**Yellowstone Pipe Line Company - Horizontal Directional Drill
Under the Spokane River at Pipeline Mile Marker 1.3
Spokane County, Washington**

**April 26, 2016
Terracon Project No. 26145031**

**Design Review Administrative Application Project Summary
April 21, 2016**

Re: Revegetation Requirements

Plan for New Block Valves

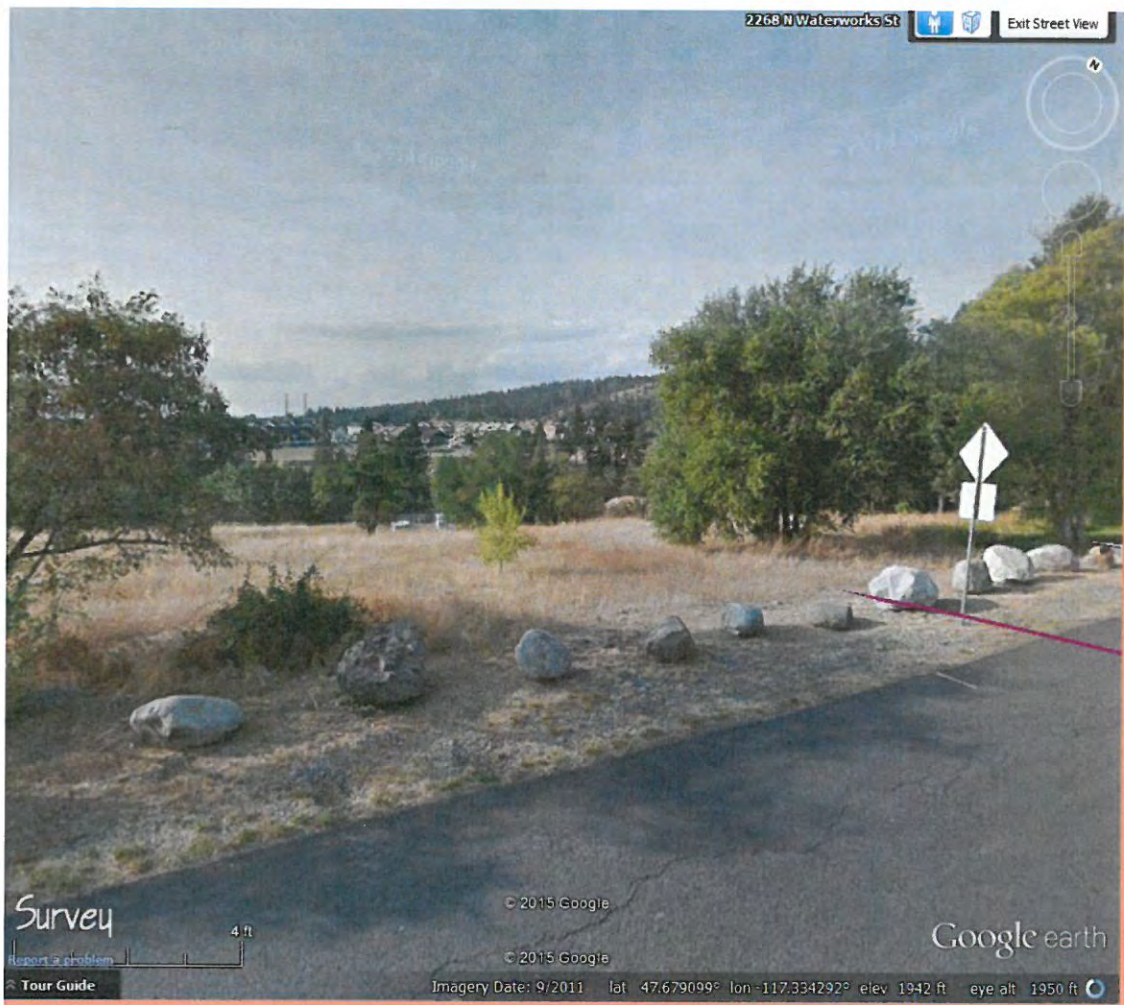
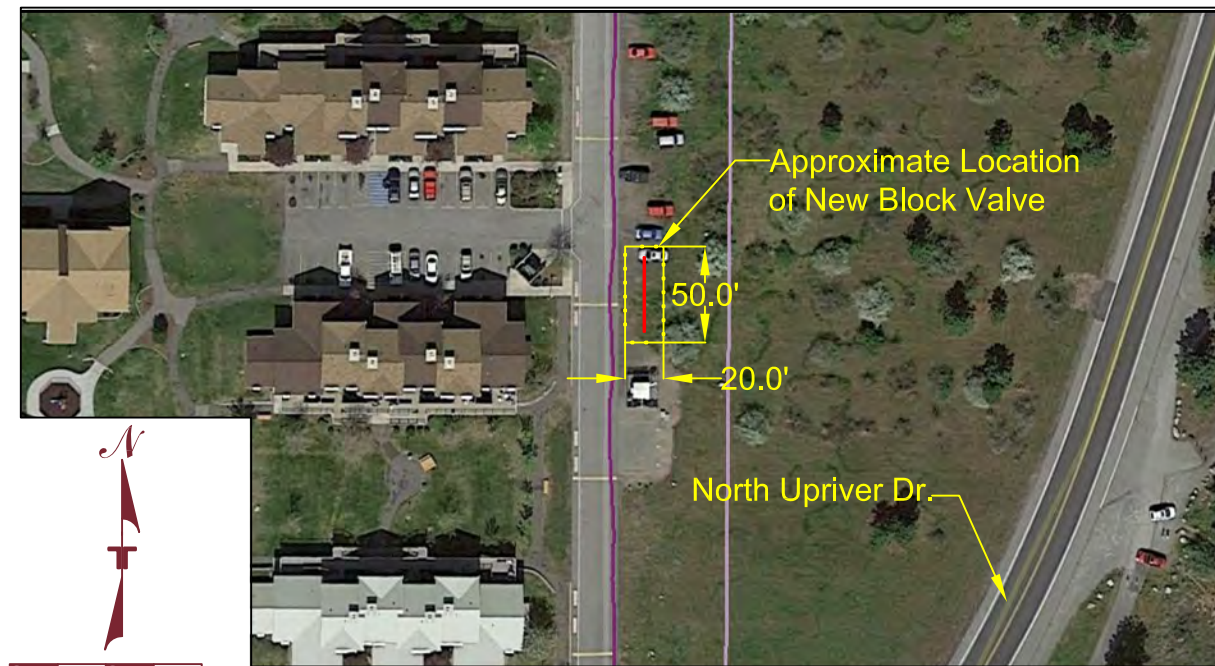
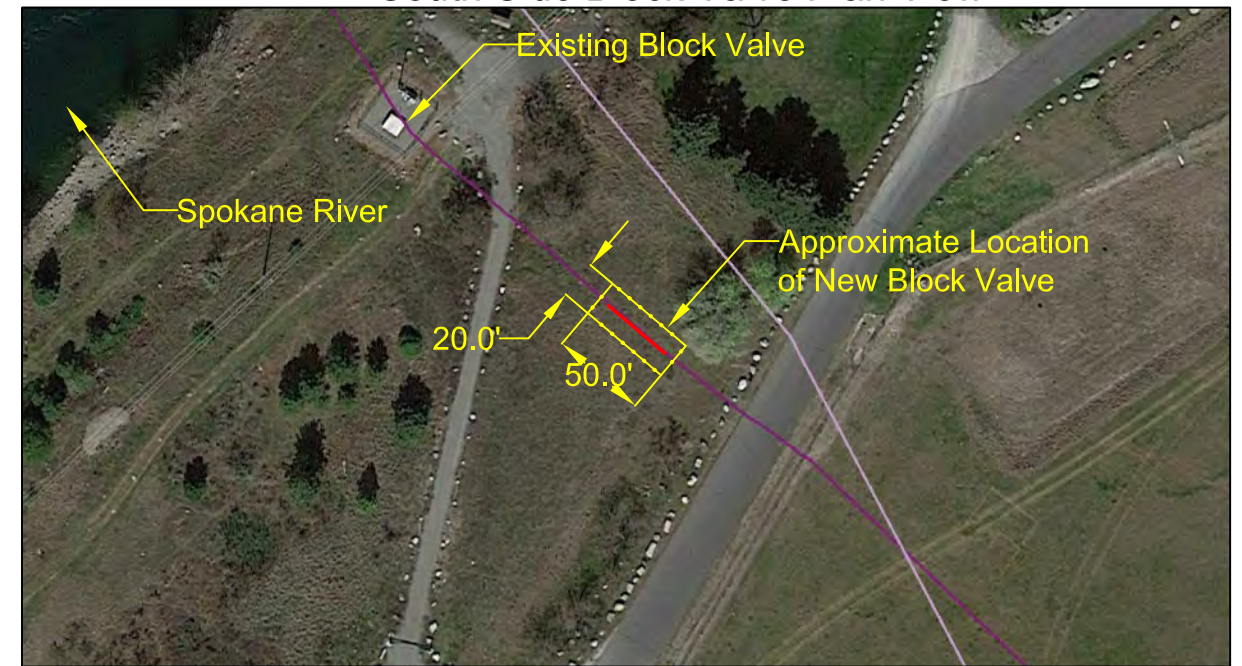
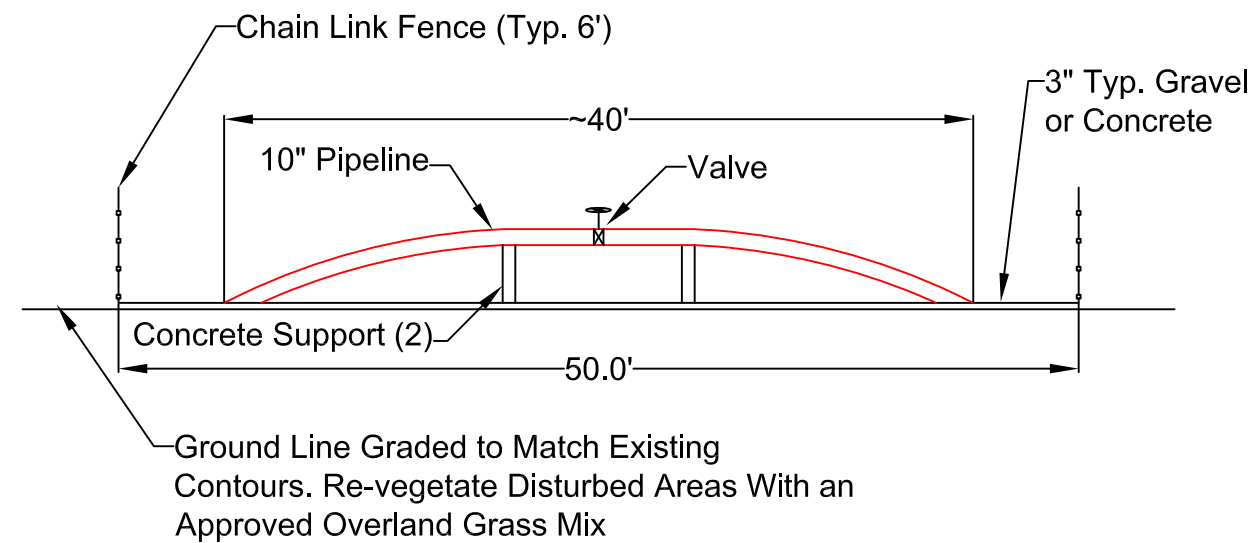
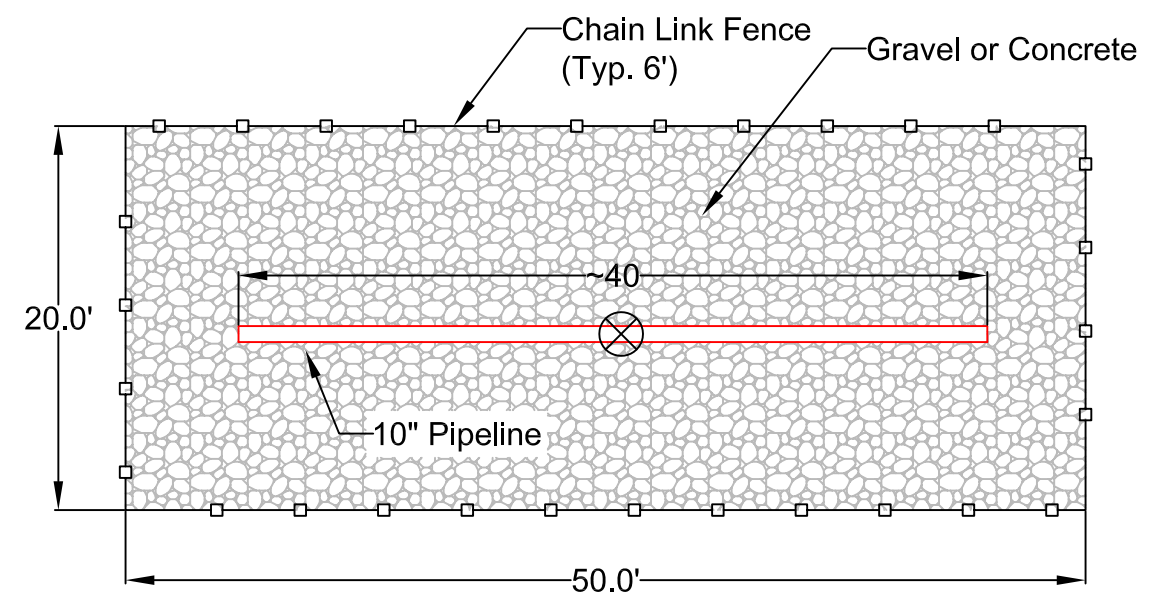
This information is being provided to the City of Spokane, to clarify the new block valve design and to address ways to mitigate the visual impacts of the block valves on City property. This issue was discussed at a recent meeting with Tami Palmquist and Elizabeth Schoedel with the City of Spokane on October 13, 2015, in relation to YPL's forthcoming application for a Conditional Use Permit.

The suggestion by the City to enclose the block valves within a rock or brick structure does not conform to currently accepted safety design for refined petroleum products facilities. Ready access to an enclosed facility would not be available as confined space safety protocols would be required for maintenance personnel. Enclosed rock or brick structures are incompatible with current industry standards for block valve enclosures for petroleum pipelines by virtue of the nature of the materials being transported in the pipe.

YPL proposes the new block valve enclosures be constructed of black 8 foot high chain link with three strand barbwire along the top of the fence, or of beige/tan 8 foot vinyl panels also with three-strand barbwire. The barbed wire is driven by YPL's Homeland Security approved system security plans. The enclosures will require a 3 foot man gate and a 12 foot wide swing gate for access and maintenance. The enclosure fence will also have two Phillips 66 signs on all four sides indicating No Smoking and the Yellowstone Pipe Line Company's phone number. Due to the large gates required for emergency access/egress, an enclosed building is impractical and would still require a 12 foot chain link section for access.

A chain link enclosure can be fitted with vinyl slats to provide additional visual screening. Vegetation screening will be incorporated around the fence exterior using shrubs native to the region that would provide some habitat for birds and small mammals. Any vegetation and landscaping rocks would have to be positioned to allow for unimpeded gate movement and access for maintenance. Any vegetation that over time would create a canopy, would have to be positioned sufficiently far from the valve and pipeline so as not to obstruct visual surveillance from the air, and whose roots would not eventually damage the pipe.

Shrubs can be planted irregularly, interspersed with boulders or in a row along the fence perimeter as shown in Photo 1. Consideration should be given to fence maintenance and grounds keeping. Landscaping elements must not interfere with the normal operation and maintenance of the pipeline. Every effort will be made to mitigate the visual impacts of the block valves with vegetation. However, if unforeseen conflicts between the landscaping and pipeline operation develop over time, YPL reserves the right to alter the vegetation on its right of way to ensure pipeline integrity.

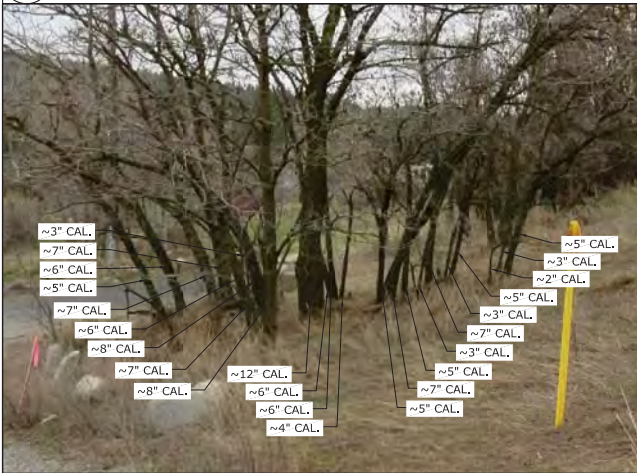
- 1. A Vegetation Replacement Plan will need to be submitted for review and approval as part of the application. Please review the Spokane Municipal Code Section 17E.060.230 Vegetation Conservation, Section 17E.060.260 Vegetation Replacement Plan, additional guidance can also be found in Section 17E.020.090."*

B. There shall be no net loss of vegetative cover within the shoreline jurisdiction.

C. Removal of or alteration to any vegetation within the shoreline jurisdiction shall not be allowed unless such activity is approved by the director as part of a vegetation replacement plan.

D. Proposed removal of vegetation for a permitted use shall be reviewed pursuant to the mitigation sequencing specified in SMC 17E.060.230. Avoidance of any impact to shoreline vegetative cover is the preferred method of mitigation.

- 1. WDFW has reviewed the Yellowstone Pipeline proposal. Given that the pipeline project will result in permanent impacts to shoreline vegetation, WDFW recommends that the City request a shoreline restoration plan with native plants in order to mitigate these impacts. The restoration work can take place just outside of the area that must be visible for aerial inspections."*

Response: Applicant has reviewed the applicable sections of the Spokane Municipal Code as noted in the staff comments and has prepared a Vegetation Replacement Plan for the areas impacted by the project.

Applicant has prepared a Vegetation Replacement Plan (L-1) to mitigate removal of existing native and non-native trees and shrubs required by construction of the project. Applicant has identified three areas where native and non-native trees and shrubs will be selectively removed and those are listed in Table 1, below.

Area A: Area along the existing asphalt driveway (Carnahan RD) serving the apartment complex and south of Buckeye Avenue. Proposed replacement areas are identified on the **plan as 'A-R'.**

a 30' strip to allow inspection of the surface over the proposed pipeline. Proposed replacement areas are identified on the plan as 'B-R'.

Area C: Southeast side of the Spokane River where the proposed project will cross under the river. Non-native trees will be selectively removed in a 30' strip to allow inspection of the surface over the proposed pipeline. Proposed replacement areas are identified on the plan as 'C-R'.

Applicant requests director's approval for the selective removal of native and non-native trees and shrubs identified on L-1 in order to comply with requirements for aerial inspection of the surface above the pipeline.

Applicant proposes to selectively remove identified native and non-native trees and shrubs in order to minimize impact to shoreline vegetative cover. Vegetative cover located directly adjacent to the Spokane River is identified on L-1 as callout #5. This shoreline vegetation is to remain.

Applicant proposes a Vegetation Replacement Plan with replacement of selectively removed native and non-native trees and shrubs that will result in no net loss of shoreline ecological functions. Applicant proposes to conduct removal and replacement operations in late summer and fall.
